ADDENDUM NO. 1

Date: March 25, 2022

Project: 0410-416, Albert Einstein Gym Floor

Action PowerChannel Sports Floor System

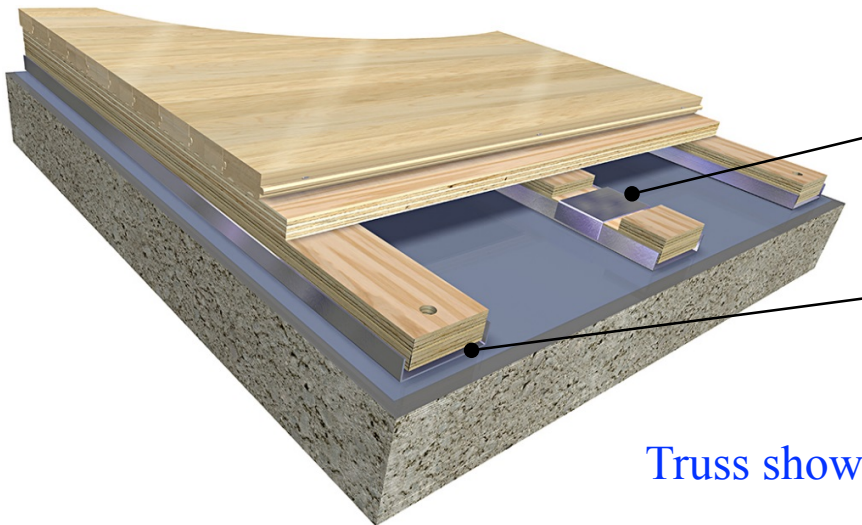
Truss shown in other drawing.

re-using steel angle base. See drawings

List of Materials

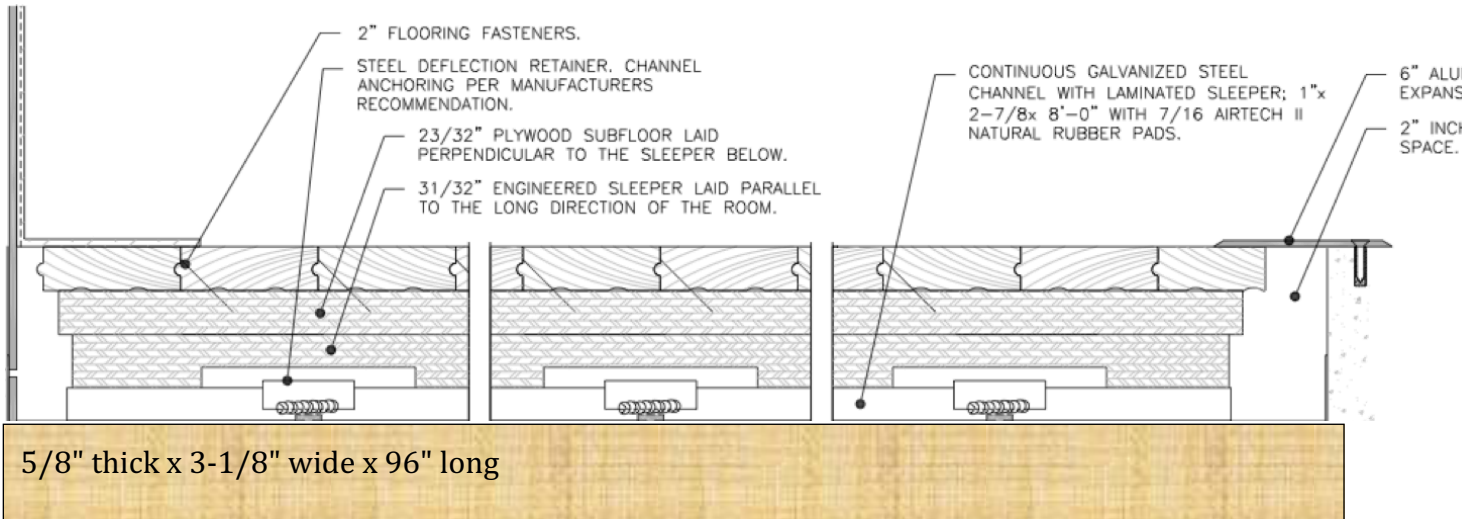
System designed for 3-1/2" slab depression. It is expected to require some shimming for irregularities in the concrete.

The power channel system is 2-7/8" tall, adding a 5/8" sleeper under the power channel, which will give a total system height of 3-1/2".

Leveling compound is part of the scope. See drawings.
